**INQUIRY INTO THE APPEAL BY CASTLEFIELD INTERNATIONAL LIMITED
AGAINST REFUSAL OF RESERVED MATTERS APPLICATION BY
SOUTH CAMBRIDGESHIRE DISTRICT COUNCIL AT
LAND AT TEVERSHAM ROAD, FULBOURN**

**PROOF OF EVIDENCE OF DR ELIZABETH SOILLEUX MA MB BChir PhD
FRCPATH PGDipMedEd**

**Planning Appeal Ref: APP/W0530/W/22/3291523
Planning Application Ref: S/3290/19/RM**

Figure C1. Letter from Cambridgeshire Geological Society about HR Wallingford assuming the wrong geology.

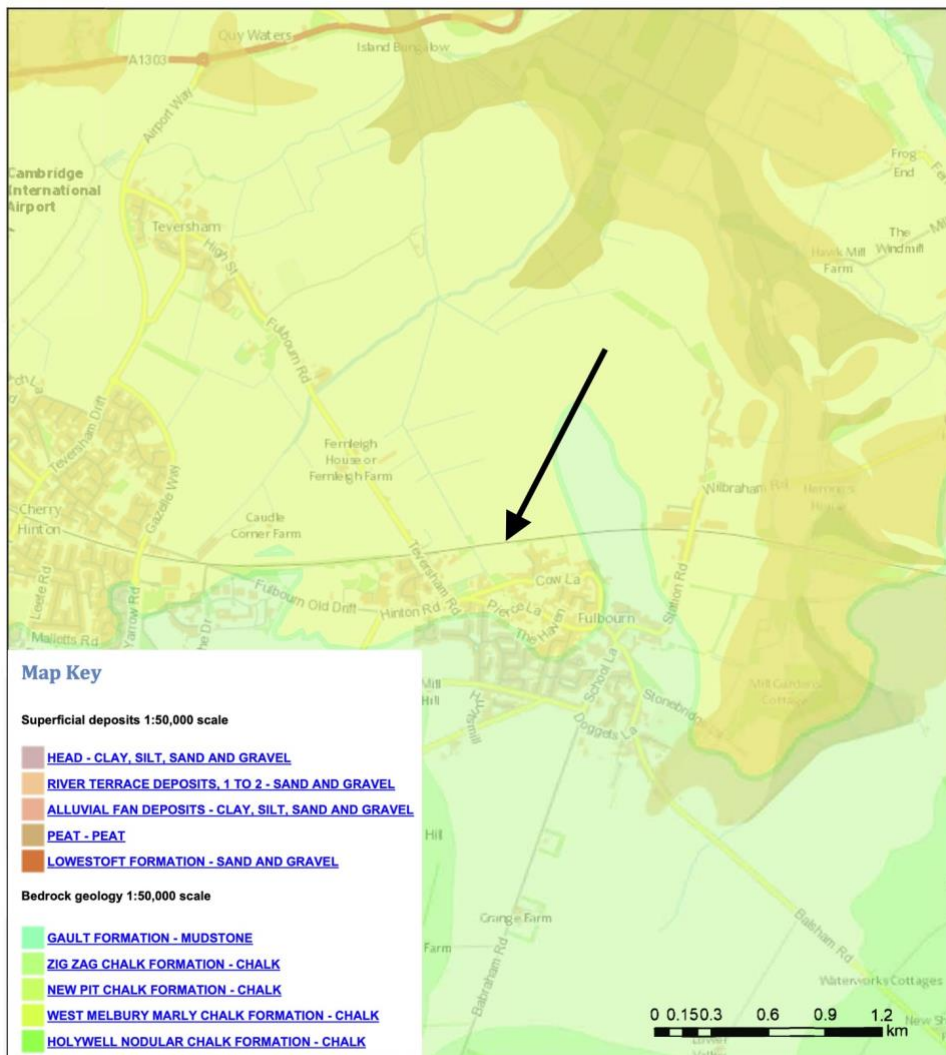
- 10 S/3290/19/RM pertains to a proposed 110 house development on the lowest lying land in Fulbourn. The site stands immediately adjacent to a large spring fed pond, Poor Well, and the area is so wet, that the underlying aquifer used to supply all of Cambridge's water in the 19th Century. Less low-lying parts of Fulbourn in the Teversham Road area flood regularly (including Roberts Way, which is 50 metres from the site, figure A1, Appendix A) and, much of the year, there is standing water at the proposed development site, with marsh-type vegetation, including reeds (figures A2 - A8, Appendix A). The underlying soil appears to local residents to be thick, boggy clay and is shown on the British Geological Survey map to be impermeable West Melbury Marly chalk (figures C1 and C2, Appendix C)⁵.

Cambridgeshire Geological Society that the site does not lie on free draining chalk, as assumed by both Cannon⁴⁷ and HR Wallingford^{48 49}, thus invalidating all of their modelling, because there will be more surface run-off and less absorption than the models have predicted. The correct geology is shown in figures C1 and C2 (Appendix C), together with a letter from Cambridgeshire Geological Society.

Figure C3. Predicted 1 in 100 year +40% flood risk before and after development version

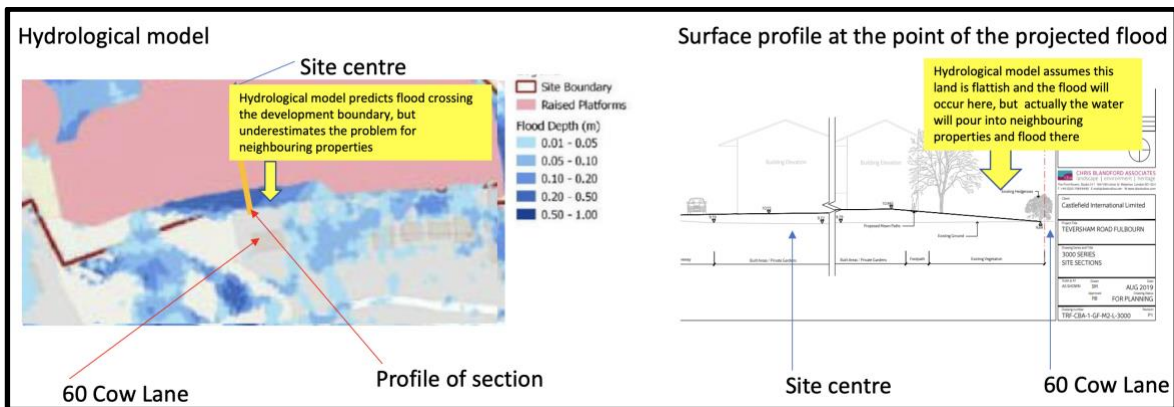
- 23 A flood modelling report was commissioned by the appellant from HR Wallingford. This was submitted on 17 August 2020^{16,17}. As shown in figures C3 and C4 (Appendix C)¹⁸, this demonstrated clearly that there was a very significantly increased flood risk to surrounding properties, particularly 60 Cow Lane. However, such increased risk is not permitted under paragraphs 159 and 164 of the National Planning Policy Framework (NPPF)¹⁹. Please note that this requirement was in paragraph 103 of the previous version of the NPPF²⁰.

Figure C5. Original site section P1 12.11.20 shows development platform sloping south to north.

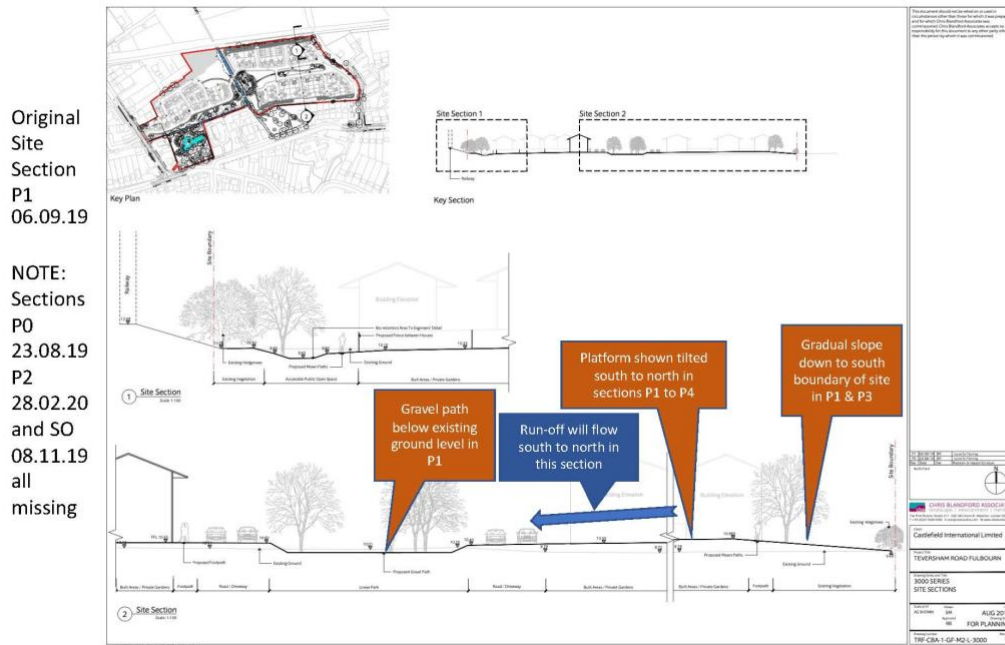
- 25 These September 2020 plans²⁴ suggested that the slope of the south-eastern development platform had been altered relative to that previously described (see paragraphs 64 - 65, figures C5 – C8, appendix C). At this point the platforms were now highest near Linear Park. Therefore, water falling onto the south-eastern development platform would be expected to drain predominantly away from the central ‘Linear Park’, towards existing housing south of the development boundary²⁵. While the intended direction of the slope is extremely unclear from the information provided, a Freedom of Information request uncovered a hand annotated diagram emailed by the appellant to the LLFA on 23 October

south-eastern development platform to tilt from south to north in all iterations up to P04 (April 2021) (figures C5 and C6, Appendix C)^{75 76}. However, the site plan with finished floor levels (also from April 2021)⁷⁷ indicated that the development was now intended to slope north to south (figures C7 and C8, Appendix C), i.e., towards the Cow Lane houses, potentially increasing water flows towards them. However, the site plan and contemporaneous site section, both from the April 2021 amendment, conflict with each other (figures C7 and C8, Appendix C)^{78 79}, regarding the direction of the slope, which raises the questions about which topology was used in the flood modelling. While the intended direction of the slope is extremely unclear from the information provided, a Freedom of Information request uncovered a hand annotated diagram emailed by the appellant to the LLFA on 23 October 2020 that indicated that the plan, at this point, was for water to flow south off the south-eastern development platform towards the southern boundary (Figure D1, Appendix D). This suggests that the site plan⁸⁰ shows the intended direction of slope and the conflicting site section⁸¹ is incorrect.

Figure C9. Predicted flood levels at southern boundary submitted to October 2021 Planning Committee Meeting.

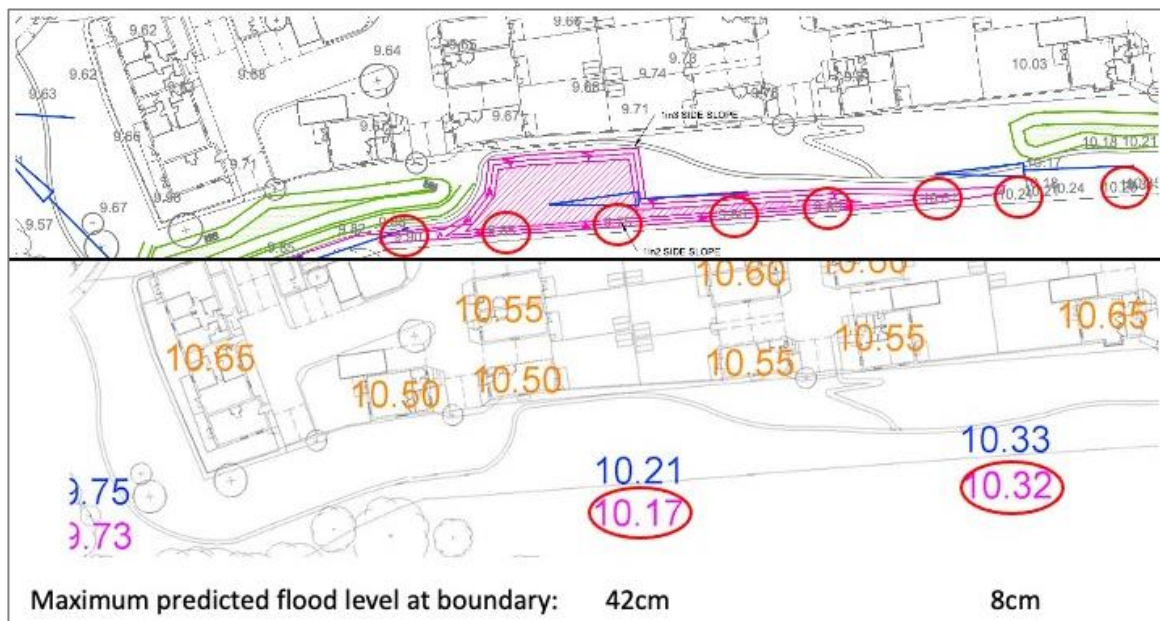
- 38 The appellant provided version P09 of their flood management strategy, with 100 year plus climate change flood levels (pink numbers) along the southern boundary⁴⁰. Adjacent to the western Cow Lane properties, these flood levels are 10.17m and 10.32m. In their Cow Lane Flood Basin document, they provided the ground heights along that boundary, as being 9.75m and 10.24m, respectively. I have aligned the relevant parts of these two plans in (figure C9, Appendix C). Simple arithmetic, using the appellant's data, shows that flood levels are substantially (8 – 42 cm) above the level of the land at this part of the southern boundary (figures C9 and C10, Appendix C), indicating predictable flooding of some of the properties along Cow Lane^{41 42}. It is presumably for this reason that the appellant has not provided modelling from HR Wallingford of this version of the plans (paragraph 78).

Figure C10. Topology data shows roof heights only for Cow Lane properties.

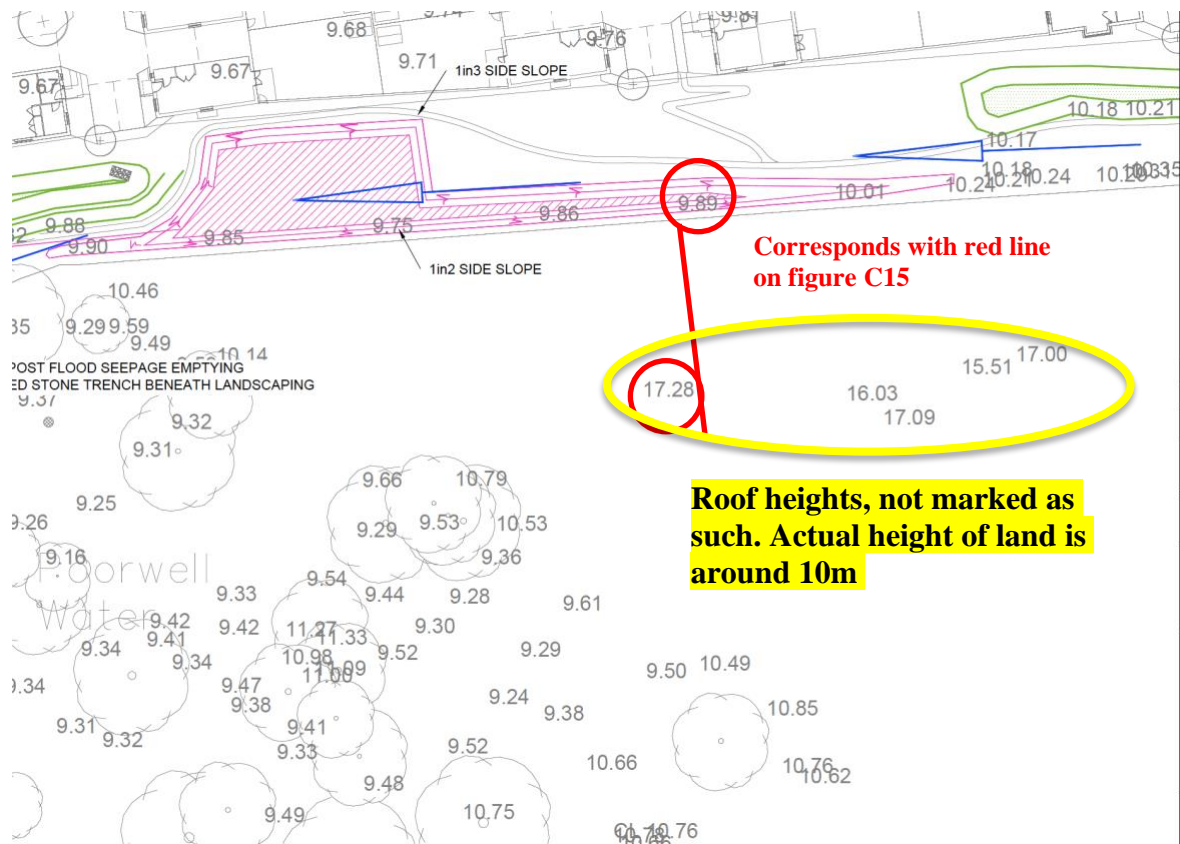
- 61 More detailed topological information was provided, as part of requested additional flood modelling data (figure C10, Appendix C)⁶⁶, but no accurate topological data for surrounding properties was included as part of the data. The only levels outside the development boundary provided were what residents presume are the roof heights of houses, in excess of 17 m, while ground levels are around 10m (figures C10 and C15, Appendix C). The appellant did not differentiate roof heights of houses from ground levels (compare figures C10 and C15, Appendix C). Residents still believe that the topology being used is inaccurate

90 We are concerned that roof heights (figure C10, Appendix C) and p8 of “CCE B411 Teversham Road Fulbourn modelling and sw note 02.pdf”¹³⁵), rather than the ground levels (shown on residents’ survey, figure C17), for surrounding properties may have been used in modelling, if these were taken into a computer model which “believed” them to be ground level. We have no way of knowing how the model handles input data, as no details are provided to us. If the model undertakes interpolation (either linear or non-linear) of the height data between two points and was fed roof height data for properties along the southern boundary, this might explain why the HR Wallingford model shows a predicted flood of 22cm at the southern boundary, but claims that no surrounding properties will be flooded (see below). Another possibility is that, when considering the topology of the surrounding land, the low resolution data in figure C16 (appendix C), rather than correct, higher resolution topological data has been used. The low resolution topological data provided by the appellant (figure C16, appendix C)¹³⁶ estimates development boundary land heights to be higher than the appellant’s own measurements^{137 138}, and also higher than those shown on the survey commissioned by residents (figure C17, Appendix C)¹³⁹.

Figure C14. Representation of average annual rainfall in Cambridge.

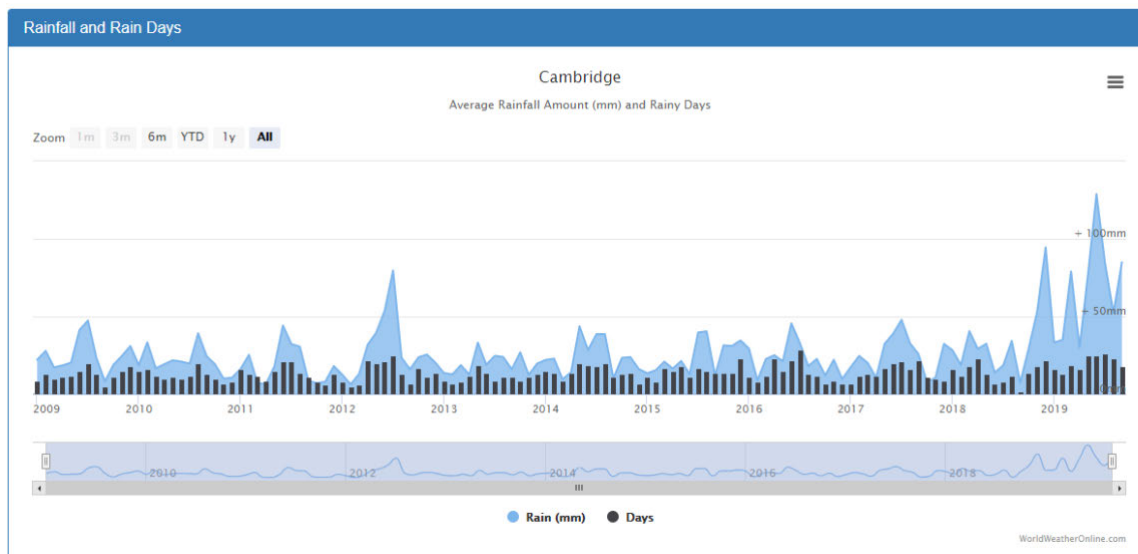
- 59 Use of non-representative data from February to July, a selection which represents the 6 months with the lowest rainfall of any possible 6 month stretch (as demonstrated in figure C13, Appendix C), has the potential to mis-assess current groundwater levels and cause the modelling to underestimate flood risk. Finally, alterations in climate, particularly increasing rainfall patterns, often with short periods of very heavy rain, are now being seen (figure C14, Appendix C). This indicates that historical water table estimates, e.g., these readings from 6-7 years ago⁶⁵ may seriously underestimate current and future winter ground water levels.

Figure C16. Topological data submitted by the appellant is in conflict with data in other appellant-submitted plans.

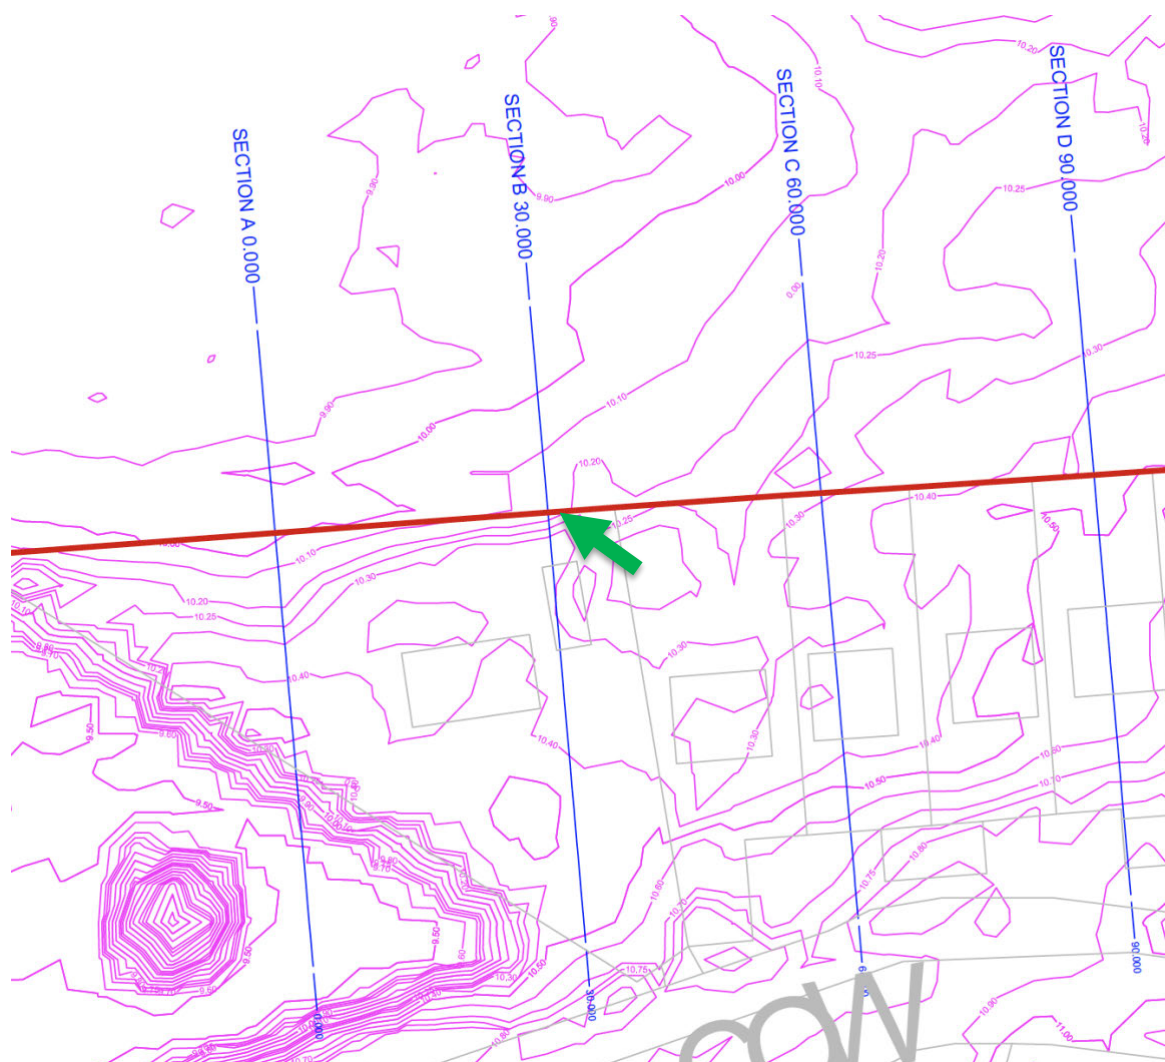
62 There are also inconsistencies in land level at the boundary on the submitted plans between different documents. The topological data submitted by the appellant in Fulbourn General Topological Plan Additional Information⁶⁷ (green arrow in figure C16, Appendix C) indicates a boundary land level with 60 Cow Lane of just below 10.2m, while other documents submitted by the appellant^{68 69} show the level to be 9.89m, which concurs with a recent survey commissioned by residents in response to these inconsistencies (figure C17, Appendix C). The LLFA and planning officer involved in this case were concerned by these inconsistencies, as shown in email correspondence obtained via a Freedom of Information request (figure D3, Appendix D). Key points demonstrated by the recent topological survey are that the appellant's ground height readings at the boundary are correct in the Cow Lane Flood Basin plan⁷⁰ (figure C10, appendix C), but not in the topology plan⁷¹ (figure C16, appendix C). These ground levels at the boundary and those measured in the garden indicate that many parts of the garden of 60 Cow Lane are below the predicted 1 in 100 +40% flood level of 10.17m in version P09 of the surface water management plans and that parts are also below 9.97m, the predicted 1 in 100 +40% flood level in the April 2022 surface water management plans submitted to the Appeal process. This indicates (even on the appellant's

Figure C18. Annotated version P09 of the surface water management plans, showing multiple non-compliances with CC/9 of South Cambridgeshire Local Plan.

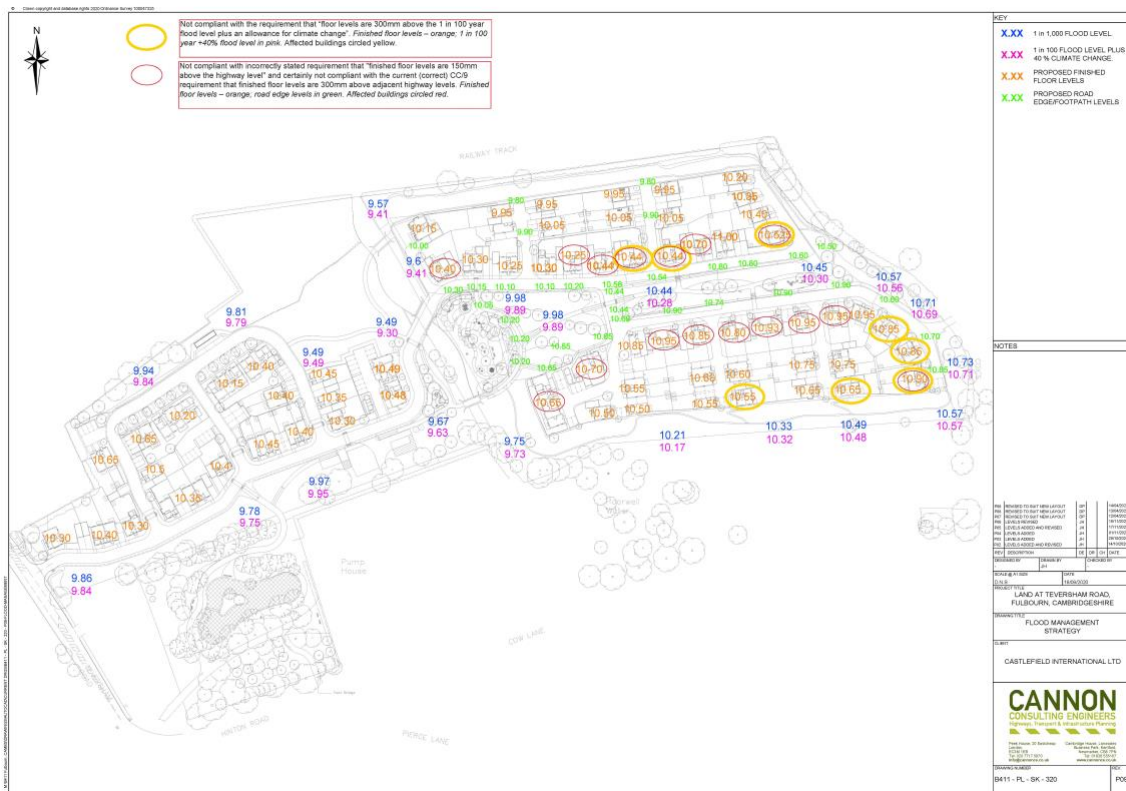
77 Version P09 of the surface water management plans¹⁰¹ showed post-development land heights across the development, together with predicted 1 in 100 year plus climate change and 1 in 1000 year flood levels and road heights (figure C18, Appendix C). While finished floor levels should be 300 mm above the levels of the roads “where appropriate and practicable” (and surely that requirement must be appropriate here, given the potential flood risk to proposed dwellings), at least 16 proposed dwellings failed that. Furthermore, finished floor levels should “where appropriate” (and again surely that requirement must be appropriate here, given the potential flood risk to proposed dwellings) be 300 mm above predicted 1 in 100 year plus climate change flood levels and at least 8 proposed dwellings fail that. Thus, the plans were not compliant with South Cambridgeshire Local Plan CC/9¹⁰², as recognised in the 13th October 2021 meeting.

Figure E1. New flood management plans presented for the Appeal, which are very different from version P09 (second version) rejected by the Planning Committee in October 2021.

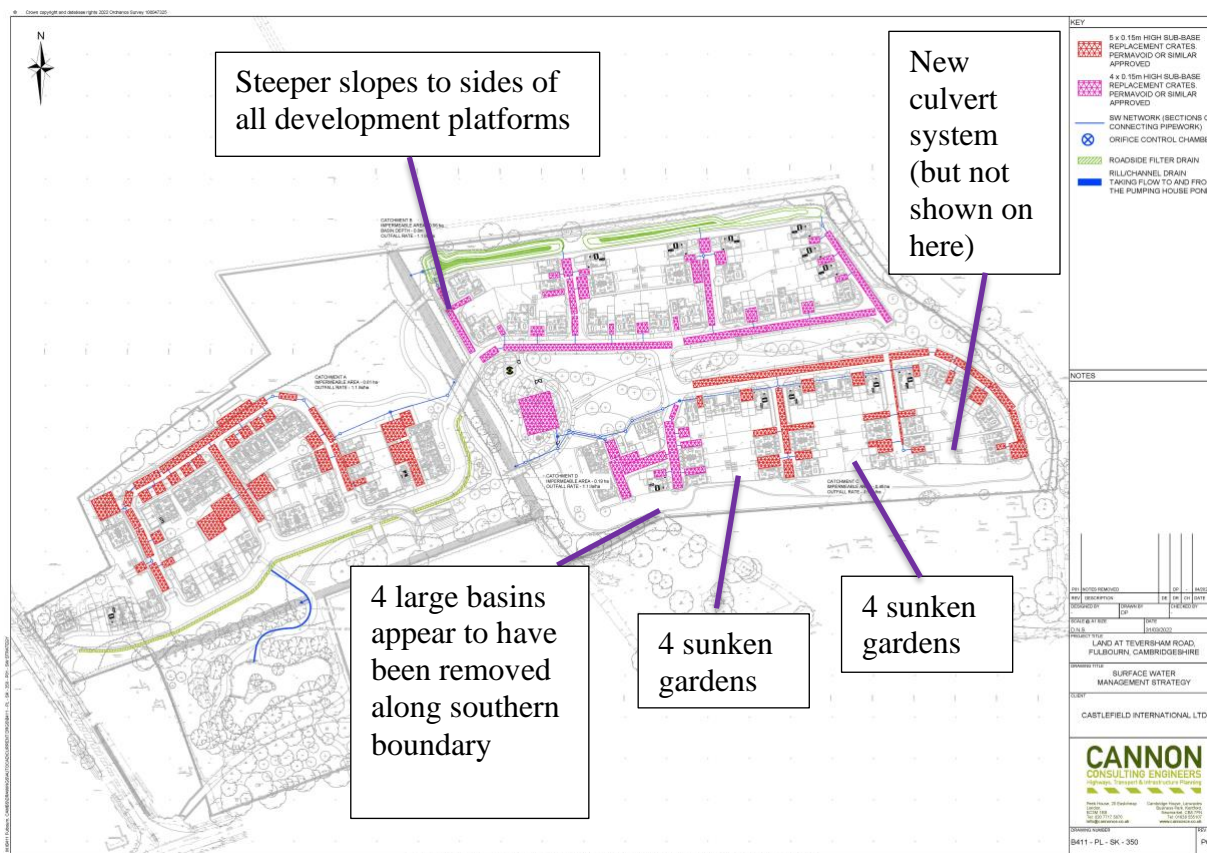
Key changes (possibly of an extent not permitted at this stage) made in April 2022 compared with the version of the surface water management and drainage strategy considered by the Planning Committee in October 2021 (summarised in figure E1, Appendix E) are:

- a. Removal of 4 proposed drainage basins (total surface area of 400-500 square metres) along the southern boundary, when page 11 of “CCE B411 Teversham Road Fulbourn modelling and sw note 02.pdf”¹¹³ is compared with TRF-CBA-1-GF-M2-L-1011 100 Series Hard Landscaping Strategy Sheet 2 (12 April 2021)¹¹⁴ , B411-PI-SK-321 Cow Lane Flood Basin (12 April 2021)¹¹⁵ and B411-PL-SK-320 Flood Management Strategy (14/4/2021)¹¹⁶.
- b. Gardens of around 8 proposed properties have been sunk 60-70cm below the houses and the rest of the development, according to pages 2 and 9 of “CCE B411 Teversham Road Fulbourn modelling and sw note 02.pdf”¹¹⁷. These gardens will deliberately be allowed to flood, in place of the 3 previously proposed drainage basins along the southern boundary, raising feasibility and safety issues and concerns about whether anybody would buy these houses (figure E1, Appendix E).
